No. TOS-CR-FPG-2019-0002

Reference: NRC Fourth Request for Additional Information Regarding the Toshiba License Topical Report "License Topical Report for Toshiba NRW-FPGA-Based Instrumentation and Control System for Safety-Related Application" (TAC NO. ME9861; EPID: L-2012-TOP-0003), dated June 10, 2019

Subject: **Toshiba Response to NRC Fourth RAI (TAC NO. ME9861; EPID: L-2012-TOP-0003)**

Enclosure – Toshiba Response to Fourth RAI**RAI Dated June 10, 2019****NRC QUESTION 1:**

Figure 1 Updated figure of the associated organizations

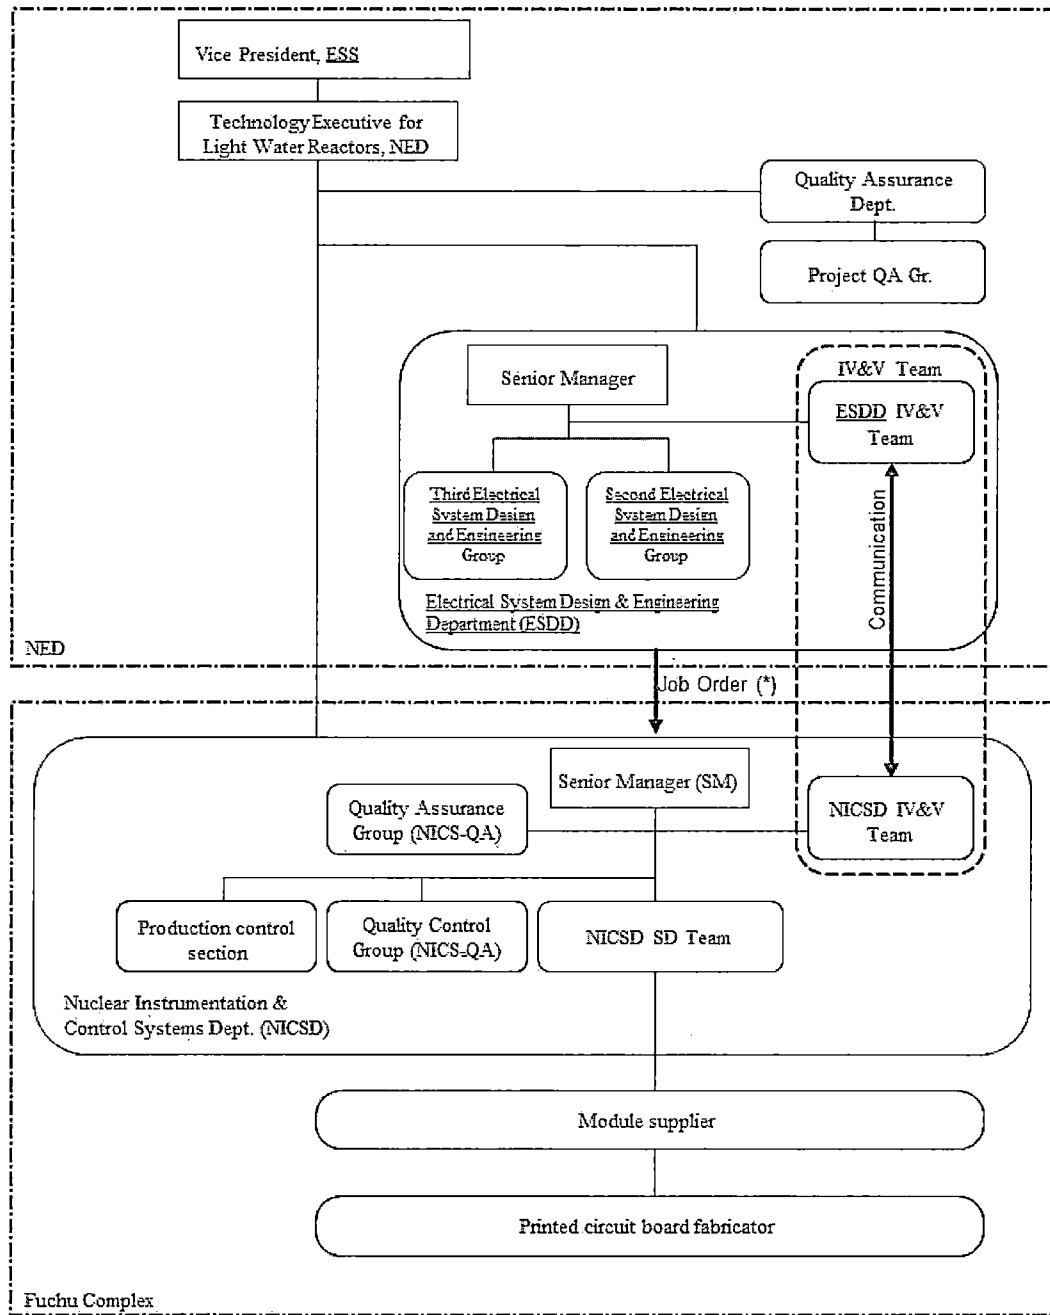
1. (Open Item 1) Please provide a clear description of Toshiba's updated organization, including roles and responsibilities of the organizations involved in the design, development and testing of the Power Range Monitor (PRM) system and Oscillation PRM unit.

Even though the following organization name changes were made, the roles and responsibilities were not changed.

- ESDD and its Second Electrical System Design and Engineering Group and Third Electrical System Design and Engineering Group had been renamed as such on April 1st, 2015 from ICDD, the Monitoring System Engineering Group and Control System Engineering Group due to department level organization change. The organization structure and the roles and responsibilities of the renamed organizations were kept unchanged. This was addressed in the footnote of Page 10 of LTR Part I Rev.2.

- On April 1st 2016, Toshiba Corporation Power Systems Company which had NED was renamed as Toshiba Corporation Energy Systems & Solutions Company. Accordingly, Fuchu-PS (Fuchu Power Systems) was renamed as Fuchu-ES (Fuchu Energy Systems) in short. The names of NED, NQAD, ESDD, and NICSD were kept unchanged and the roles and responsibilities of these departments were also kept unchanged. The name “Fuchu Complex” is used when it represents the entire Fuchu site.
- On October 1st 2017, Toshiba Corporation Energy Systems & Solutions Company with its all divisions including NED and Fuchu-ES was established as Toshiba Energy Systems & Solutions Corporation (Toshiba ESS), acting as a subsidiary of Toshiba Corporation. The roles and responsibilities of NQAD and ESDD under NED and NICSD under Fuchu-ES were not changed.

Figure 1 provides the updated figure of Figure I-1-2 of LTR Part I Rev.2 in which above mentioned items were incorporated. The changed parts were underlined.

Note: On April 1st, 2019, NED merged with another division of Toshiba ESS and changed its name to Power Systems Division. NQAD and NICS were renamed as QAD and Nuclear Systems Control Department respectively. The roles and responsibilities were unchanged and the organization names in the QA program documents have not been changed yet.
